City of Sandy

Planning Commission Meeting

5.1. Deer Meadows Subdivision

**PLANNING COMMISSION STAFF REPORT
TYPE III LAND USE PROPOSAL**

STREET TREE PLAN & PARKING ANALYSIS

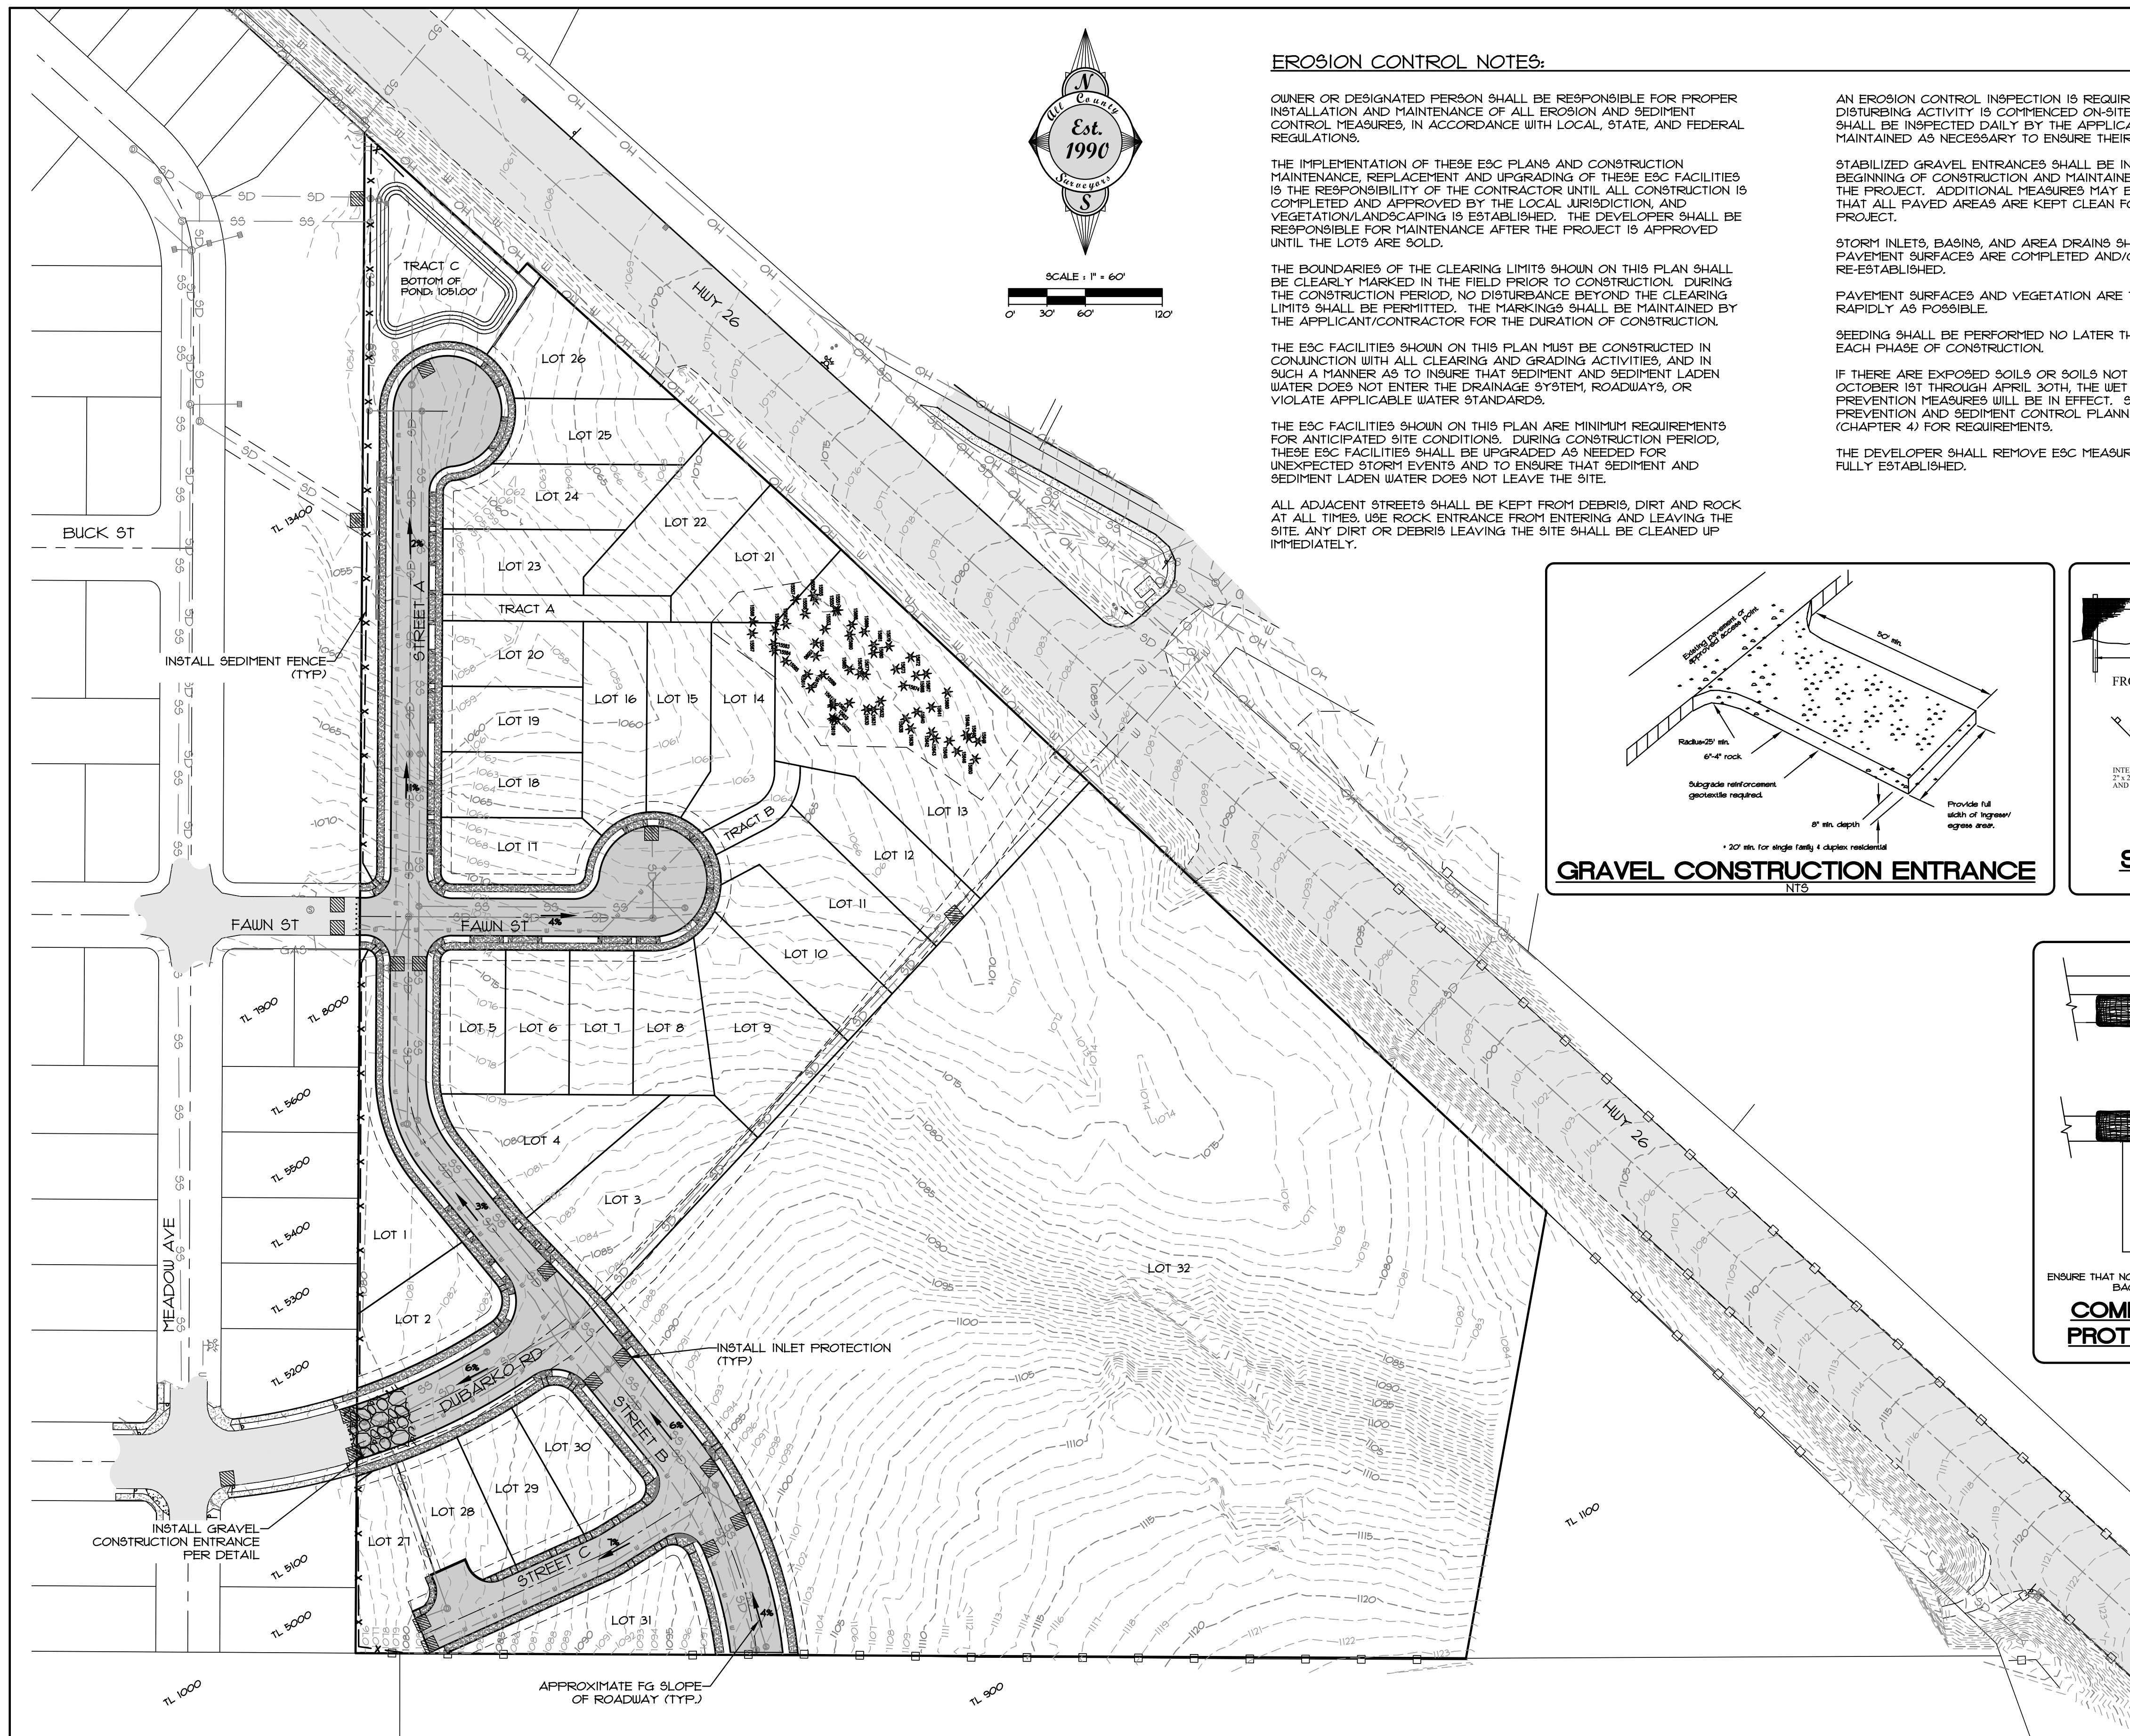
has been identified within 300 feet of each of the 30 lots zoned as R-1 as required. Exhibit C, Sheet C6 shows that 47 on-street parking spaces have been identified in compliance with this standard. No parking courts are proposed by the applicant.
